Access Compliance Report Public Rights-of-Way (Curb Ramps)

Main Street: MONTECITO_RD Cross Street: BRADBURY_RD Location: NE

ADA ID: RPRK211209131336 Ramp Type: Type 1 - Perpendicular Diagonal Initial Pass/Fail: Pass Overall Compliance: No Severity Score: 4

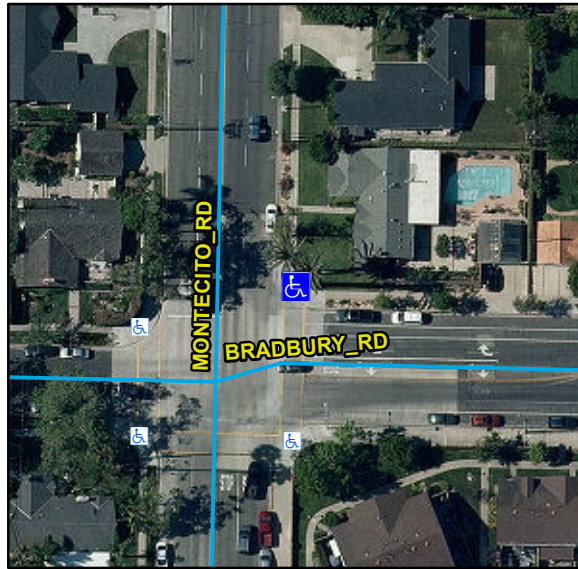
R304.2.2, R304.2.1, R304.5.3, STD 1115

Remove & Replace Curb Ramp With Two New Directional Ramps or Equivalent. Remove & Replace Gutter.
